Vogtle Electric Generating Plant – Units 1 and 2
Second 10-Year Interval Inservice Inspection Program
Submittal of Relief Requests

1. RR-43, Vogtle – Units 1 and 2 Pressurizer Nozzle to Safe-End Welds
2. RR-44, Vogtle – Unit 1 Class 1 Cast Stainless Piping Butt Welds
3. RR-45, Vogtle – Units 1 and 2 Class 1 Stainless Steel Piping Butt Welds
4. RR-46, Vogtle – Unit 2 Class 2 Stainless Steel Piping Butt Welds
5. RR-47, Vogtle – Units 1 and 2 Class 1 and 2 Stainless Steel Piping Butt Welds (RI-ISI)
6. RR-48, Vogtle – Unit 2 Class 2 Ferritic Steel Piping Butt Welds (RI-ISI)
7. RR-49, Vogtle – Units 1 and 2 Reactor Pressure Vessel Shell and Bottom Head Welds
8. RR-50, Vogtle – Units 1 and 2 Class 2 Vessel Weld Examinations
9. RR-51, Vogtle – Units 1 and 2 Class 2 Residual Heat Removal Heat Exchanger Shell Welds

**SOUTHERN NUCLEAR OPERATING COMPANY
PROPOSED RELIEF REQUEST IN ACCORDANCE WITH 10 CFR 50.55a(g)(5)(iii)
RR-43 Version 1.0**

FIGURE RR-47

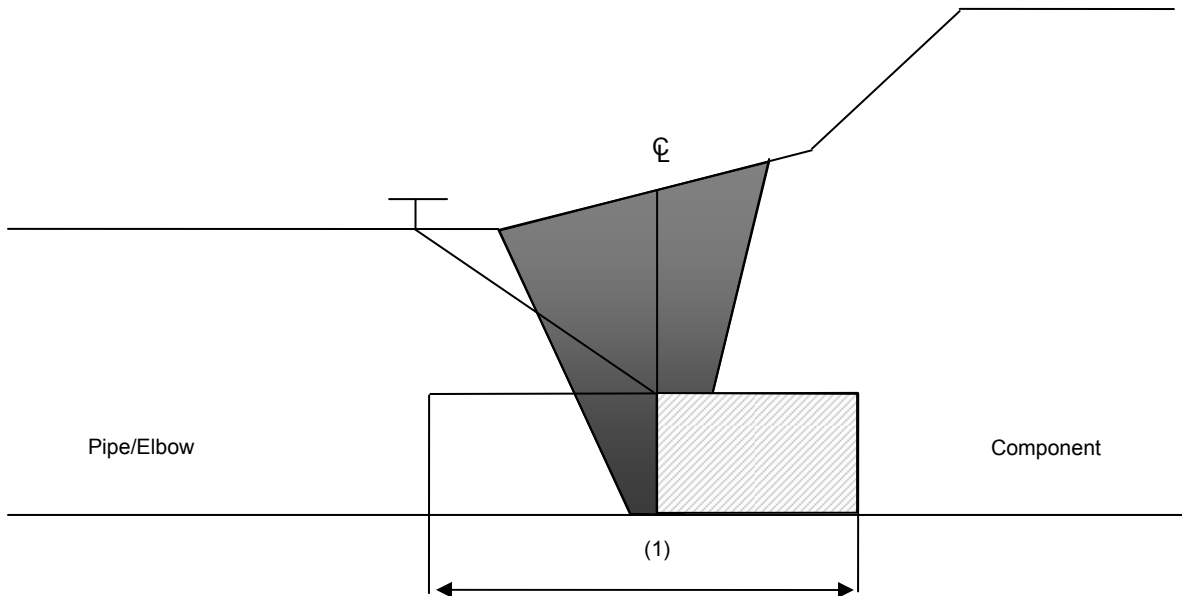
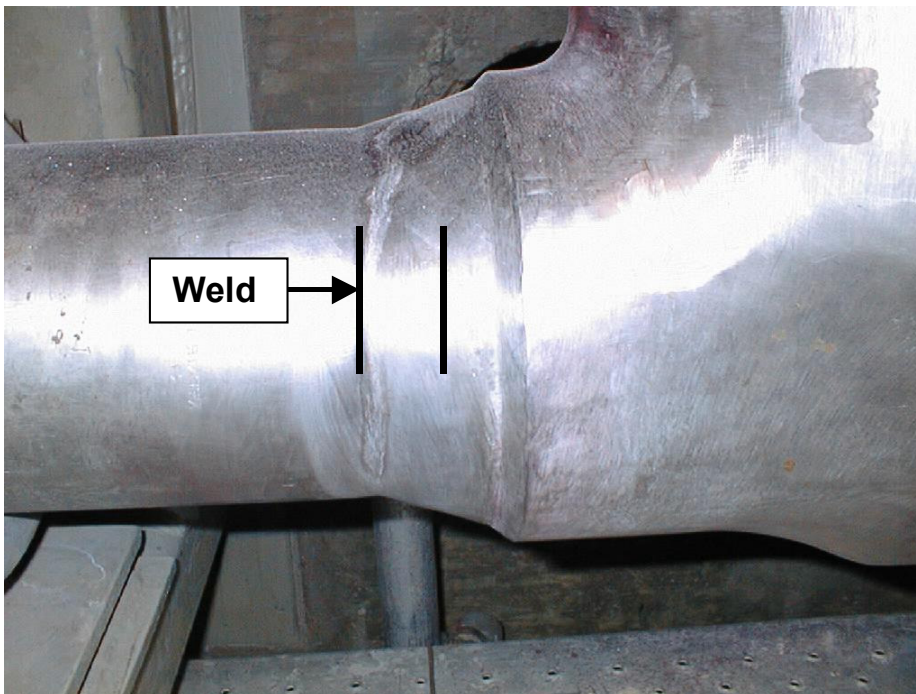
| Table RR-47-1: Class 1 Piping Welds | | | | |
|--|--------------------|---|-----------------|-------------------------------|
| 11204-021-16-RI 1R12 (Spring 2005 Outage) | 6" Pipe to Valve | Post-PDI examination. Complete ultrasonic examination from the pipe side. No examination coverage from the valve side due to configuration. See Figure RR-47 for typical picture and coverage. Per 10 CFR 50.55a(b)(2)(xv)(A)(2) when examination from both sides is not possible on austenitic welds, full coverage credit from a single side may be claimed only after completing a successful single-sided Appendix VIII demonstration using flaws on the opposite side of the weld. Since PDI qualifications do not meet requirements for flaws on the opposite side of the weld, only 50% of the Code coverage can be credited. | 50% UT | UT Indication due to Geometry |
| 11204-023-15-RI 1R11 (Fall 2003 Outage) | 6" Pipe to Valve | Post-PDI examination. Limited ultrasonic examination from the pipe side. No examination coverage from the valve side due to configuration. See Figure RR-47 for typical picture and coverage. Per 10 CFR 50.55a(b)(2)(xv)(A)(2) when examination from both sides is not possible on austenitic welds, full coverage credit from a single side may be claimed only after completing a successful single-sided Appendix VIII demonstration using flaws on the opposite side of the weld. Since PDI qualifications do not meet requirements for flaws on the opposite side of the weld, only 50% of the Code coverage can be credited. Also, the pipe side had an additional limitation due to support steel interference which reduced the overall coverage to 40%. | 40% UT | No Recordable Indications |
| 21204-021-16-RI 2R10 (Spring 2004 Outage) | 6" Pipe to Valve | Post-PDI examination. Complete ultrasonic examination from the pipe side. No examination coverage from the valve side due to configuration. See Figure RR-47 for typical picture and coverage. Per 10 CFR 50.55a(b)(2)(xv)(A)(2) when examination from both sides is not possible on austenitic welds, full coverage credit from a single side may be claimed only after completing a successful single-sided Appendix VIII demonstration using flaws on the opposite side of the weld. Since PDI qualifications do not meet requirements for flaws on the opposite side of the weld, only 50% of the Code coverage can be credited. | 50% UT | UT Indication due to Geometry |

| Table RR-47-1: Class 1 Piping Welds | | | | |
|---|--------------------|--|-----------------|----------------------------|
| 21204-023-15R-RI 2R12 (Spring 2007 Outage) | 6" Pipe to Valve | Post-PDI examination. Baseline examination after valve replacement. Complete ultrasonic examination from the pipe side for circumferential flaws. No examination coverage from the valve side due to configuration. Limited ultrasonic examination for clockwise and counterclockwise scans (for axial flaws) on the weld due to the taper. See Figure RR-47 for typical picture and coverage. Per 10 CFR 50.55a(b)(2)(xv)(A)(2) when examination from both sides is not possible on austenitic welds, full coverage credit from a single side may be claimed only after completing a successful single-sided Appendix VIII demonstration using flaws on the opposite side of the weld. Since PDI qualifications do not meet requirements for flaws on the opposite side of the weld, only 50% of the Code coverage can be credited. However, with the additional limitations for the clockwise and counterclockwise scans the overall coverage is reduced to 35%. | 35% UT | No Recordable Indications |
| 21204-023-16R-RI 2R12 (Spring 2007 Outage) | 6" Valve to Pipe | Post-PDI examination. Baseline examination after valve replacement. Complete ultrasonic examination from the pipe side for circumferential flaws. No examination coverage from the valve side due to configuration. Limited ultrasonic examination for clockwise and counterclockwise scans (for axial flaws) on the weld due to the taper. See Figure RR-47 for typical picture and coverage. Per 10 CFR 50.55a(b)(2)(xv)(A)(2) when examination from both sides is not possible on austenitic welds, full coverage credit from a single side may be claimed only after completing a successful single-sided Appendix VIII demonstration using flaws on the opposite side of the weld. Since PDI qualifications do not meet requirements for flaws on the opposite side of the weld, only 50% of the Code coverage can be credited. However, with the additional limitations for the clockwise and counterclockwise scans the overall coverage is reduced to 35%. | 35% UT | No Recordable Indications |

| Table RR-47-2: Class 2 Piping Welds | | | | |
|--|----------------------------------|--|-----------------|---------------------------------|
| 11204-038-1-RI 1R11 (Fall 2003 Outage) | 14" Branch Connection to Pipe | Post-PDI examination. Complete ultrasonic examination from the pipe side. No examination coverage from the branch connection side due to configuration. See Figure RR-47 for typical picture and coverage. Per 10 CFR 50.55a(b)(2)(xv)(A)(2) when examination from both sides is not possible on austenitic welds, full coverage credit from a single side may be claimed only after completing a successful single-sided Appendix VIII demonstration using flaws on the opposite side of the weld. Since PDI qualifications do not meet requirements for flaws on the opposite side of the weld, only 50% of the Code coverage can be credited. | 50% UT | No Recordable Indications |
| 11204-063-28-RI 1R11 (Fall 2003 Outage) | 4" Valve to Pipe | Post-PDI examination. Complete ultrasonic examination from the pipe side. No examination coverage from the valve side due to configuration. See Figure RR-47 for typical picture and coverage. Per 10 CFR 50.55a(b)(2)(xv)(A)(2) when examination from both sides is not possible on austenitic welds, full coverage credit from a single side may be claimed only after completing a successful single-sided Appendix VIII demonstration using flaws on the opposite side of the weld. Since PDI qualifications do not meet requirements for flaws on the opposite side of the weld, only 50% of the Code coverage can be credited. | 50% UT | No Recordable Indications |
| 11204-177-13-RI 1R11 (Fall 2003 Outage) | 8" Pipe to Valve | Post-PDI examination. Complete ultrasonic examination from the pipe side. No examination coverage from the valve side due to configuration. See Figure RR-47 for typical picture and coverage. Per 10 CFR 50.55a(b)(2)(xv)(A)(2) when examination from both sides is not possible on austenitic welds, full coverage credit from a single side may be claimed only after completing a successful single-sided Appendix VIII demonstration using flaws on the opposite side of the weld. Since PDI qualifications do not meet requirements for flaws on the opposite side of the weld, only 50% of the Code coverage can be credited. | 50% UT | No Recordable Indications |

| Table RR-47-2: Class 2 Piping Welds | | | | |
|---|---------------------------------|--|-----------------|---|
| 11204-192-4-RI 1R11 (Fall 2003 Outage) | 8" Pipe to Branch Connection | Post-PDI examination. Complete ultrasonic examination from the pipe side. No examination coverage from the branch connection side due to configuration. See Figure RR-47 for typical picture and coverage. Per 10 CFR 50.55a(b)(2)(xv)(A)(2) when examination from both sides is not possible on austenitic welds, full coverage credit from a single side may be claimed only after completing a successful single-sided Appendix VIII demonstration using flaws on the opposite side of the weld. Since PDI qualifications do not meet requirements for flaws on the opposite side of the weld, only 50% of the Code coverage can be credited. | 50% UT | No Recordable Indications |
| 21204-006-2-RI 2R11 (Fall 2005 Outage) | 24" Valve to Elbow | Post-PDI examination. Complete ultrasonic examination from the elbow side. No examination coverage from the valve side due to configuration. See Figure RR-47 for typical picture and coverage. Per 10 CFR 50.55a(b)(2)(xv)(A)(2) when examination from both sides is not possible on austenitic welds, full coverage credit from a single side may be claimed only after completing a successful single-sided Appendix VIII demonstration using flaws on the opposite side of the weld. Since PDI qualifications do not meet requirements for flaws on the opposite side of the weld, only 50% of the Code coverage can be credited. | 50% UT | UT Indications due to Geometry |
| 21204-008-10-RI 2R10 (Spring 2004 Outage) | 8" Pipe to Valve | Post-PDI examination. Complete ultrasonic examination from the pipe side. No examination coverage from the valve side due to configuration. See Figure RR-47 for typical picture and coverage. Per 10 CFR 50.55a(b)(2)(xv)(A)(2) when examination from both sides is not possible on austenitic welds, full coverage credit from a single side may be claimed only after completing a successful single-sided Appendix VIII demonstration using flaws on the opposite side of the weld. Since PDI qualifications do not meet requirements for flaws on the opposite side of the weld, only 50% of the Code coverage can be credited. | 50% UT | No Recordable Indications |

| Table RR-47-2: Class 2 Piping Welds | | | | |
|--|---------------------------------|--|-----------------|---------------------------------|
| 21204-039-1-RI 2R10 (Spring 2004 Outage) | 6" Valve to Pipe | Post-PDI examination. Complete ultrasonic examination from the pipe side. No examination coverage from the valve side due to configuration. See Figure RR-47 for typical picture and coverage. Per 10 CFR 50.55a(b)(2)(xv)(A)(2) when examination from both sides is not possible on austenitic welds, full coverage credit from a single side may be claimed only after completing a successful single-sided Appendix VIII demonstration using flaws on the opposite side of the weld. Since PDI qualifications do not meet requirements for flaws on the opposite side of the weld, only 50% of the Code coverage can be credited. | 50% UT | No Recordable Indications |
| 21204-192-4-RI 2R10 (Spring 2004 Outage) | 8" Pipe to Branch Connection | Post-PDI examination. Complete ultrasonic examination from the pipe side. No examination coverage from the branch connection side due to configuration. See Figure RR-47 for typical picture and coverage. Per 10 CFR 50.55a(b)(2)(xv)(A)(2) when examination from both sides is not possible on austenitic welds, full coverage credit from a single side may be claimed only after completing a successful single-sided Appendix VIII demonstration using flaws on the opposite side of the weld. Since PDI qualifications do not meet requirements for flaws on the opposite side of the weld, only 50% of the Code coverage can be credited. | 50% UT | No Recordable Indications |

FIGURE RR-48

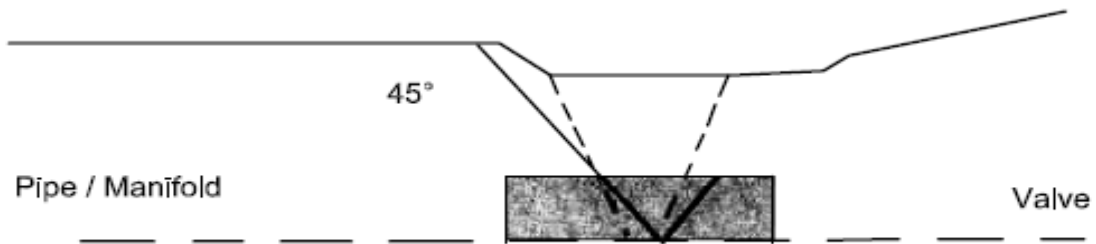
| Identification No. | Description | Limitation | Coverage | Examination Results |
|---|-------------------------------------|---|-----------------|------------------------------|
| 21301-004-10-RI 2R10 (Spring 2004 Outage) | 29.5-Inch Manifold Pipe to Valve | Post-PDI examination after the implementation of RI-ISI (therefore, no surface examination is performed). There was no examination coverage from the valve side and limited ultrasonic examination from the pipe side due to the configuration. See Figure RR-48 for picture. | 75% UT | No Recordable Indications |

| Proposed Alternative and Basis for Use: | The ultrasonic examinations were performed after the implementation of Appendix VIII and consist of primarily a single-sided examination from the manifold piping. The root area of the weld was interrogated with a 45° shear wave looking for circumferential cracking. In addition, VT-2 visual examinations are performed each ISI period for the weld listed in Table RR-48. These examinations and tests provide reasonable assurance of structural integrity of this weld. Therefore, relief should be granted per 10 CFR 50.55a(g)(6)(i). |

Figure RR-50-1 for RHR Heat Exchanger Nozzle Welds

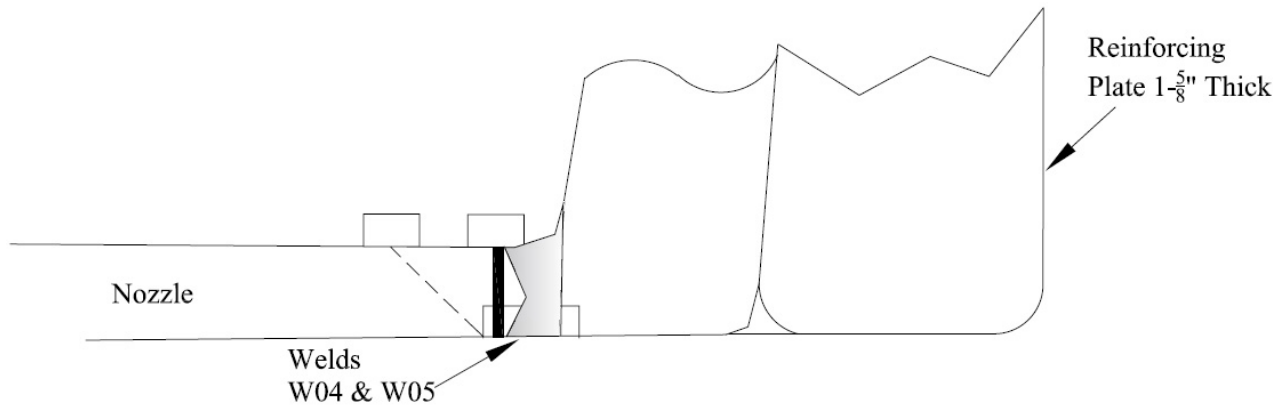
| TABLE RR-50 | | | | |
|---|------------------|---------------------|---|---|
| 11205-E6-002-W04 1R12 (Spring 2005 Outage) | C2.21 | 100% PT 41.5% UT | This is a stainless steel heat exchanger. Due to the configuration (see Figure RR-50-1), the axial scans looking for circumferential cracking were performed only from the nozzle side. Axial scan coverage from the nozzle side was complete; however, because the material is stainless steel, only 50% of the examination volume was conservatively credited for examination. There were limited circumferential scans looking for axial cracking due to the weld configuration. 100% surface examination performed. | No Recordable Indications |
| 11205-E6-002-W05 1R12 (Spring 2005 Outage) | C2.21 | 100% PT 41.5% UT | This is a stainless steel heat exchanger. Due to the configuration (see Figure RR-50-1), the axial scans looking for circumferential cracking were performed only from the nozzle side. Axial scan coverage from the nozzle side was complete; however, because the material is stainless steel, only 50% of the examination volume was conservatively credited for examination. There were limited circumferential scans looking for axial cracking due to the weld configuration. 100% surface examination performed. | No Recordable Indications |
| 21205-E6-002-W04 2R12 (Spring 2007 Outage) | C2.21 | 100% PT 41.5% UT | This is a stainless steel heat exchanger. Due to the configuration (see Figure RR-50-1), the axial scans looking for circumferential cracking were performed only from the nozzle side. Axial scan coverage from the nozzle side was complete; however, because the material is stainless steel, only 50% of the examination volume was conservatively credited for examination. There were limited circumferential scans looking for axial cracking due to the weld configuration. 100% surface examination performed. | Code-allowable PT indication; No Recordable UT Indications |

| Weld Number / Examined | ASME Item | Coverage | Limitations | Examination Results |
|---|------------------|---------------------|---|--|
| 21205-E6-002-W05 2R12 (Spring 2007 Outage) | C2.21 | 100% PT 41.5% UT | This is a stainless steel heat exchanger. Due to the configuration (see Figure RR-50-1), the axial scans looking for circumferential cracking were performed only from the nozzle side. Axial scan coverage from the nozzle side was complete; however, because the material is stainless steel, only 50% of the examination volume was conservatively credited for examination. There were limited circumferential scans looking for axial cracking due to the weld configuration. 100% surface examination performed. | No Recordable PT Indications; Code-allowable UT indication |

| Proposed Alternative and Basis for Use: | A surface examination was performed on these welds. The inspection volume of all five welds was interrogated with UT from one side of the weld looking for circumferential cracking. In addition, VT-2 visual examinations associated with the Class 2 leakage test are performed once an ISI period on all of these welds. These examinations and tests provide reasonable assurance that structural integrity is being maintained; therefore, relief should be granted per 10 CFR 50.55a(g)(6)(i). |

Figure RR-50-2 for Steam Generator 4 Nozzle Weld

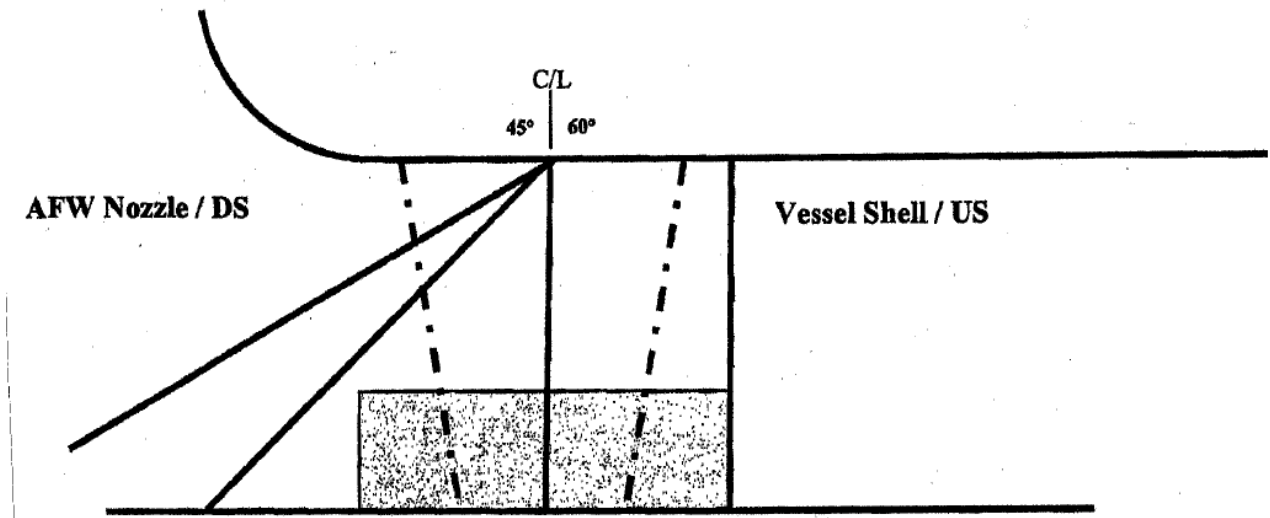
| Weld Number / Examined | ASME Item | Coverage | Limitations | Examination Results |
|---|------------------|---------------------|---|--|
| 21201-B6-004-W26 2R10 (Spring 2004 Outage) | C2.21 | 100% MT 50% UT | This is a carbon steel steam generator. Due to the configuration (see Figure RR-50-2), the axial scans looking for circumferential cracking were performed only from the vessel side. Axial scan coverage from the vessel side was complete. Circumferential scans looking for axial cracking were limited to the weld and vessel side. 100% surface examination performed. | No Recordable Indications |

Figure RR-51 for RHR Heat Exchanger Shell Welds

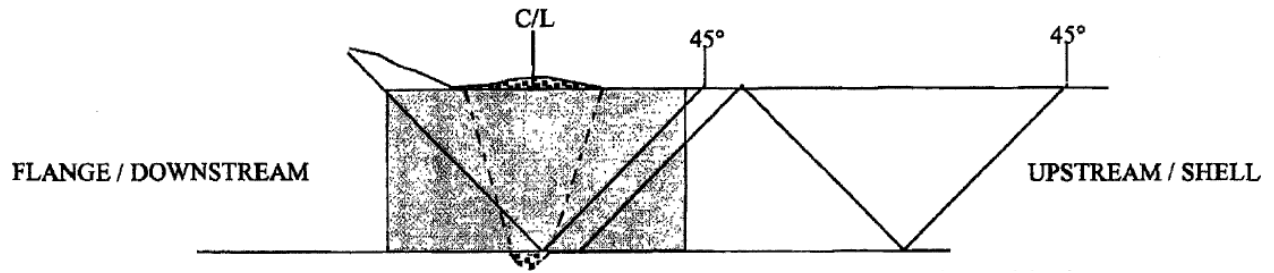
| Weld Number / Examined | ASME Item | Coverage | Limitations | Examination Results |
|---|------------------|-----------------|---|--------------------------------|
| 11205-E6-002-W01 1R10 (Spring 2002 Outage) | C1.10 | 55% UT | No examination coverage from the flange side due to the configuration. Limited clockwise and counterclockwise scans (for axial flaws) on the weld due to the weld configuration. See Figure RR-51 for coverage. | No Recordable Indications |
| 21205-E6-002-W01 2R09 (Fall 2002 Outage) | C1.10 | 56% UT | No examination coverage from the flange side due to the configuration. Limited clockwise and counterclockwise scans (for axial flaws) on the weld due to the weld configuration. See Figure RR-51 for coverage. | UT indications due to Geometry |

2 leakage test are performed once an ISI period on all of these welds. These examinations and tests provide reasonable assurance that structural integrity is being maintained; therefore, relief should be granted per 10 CFR 50.55a(g)(6)(i).
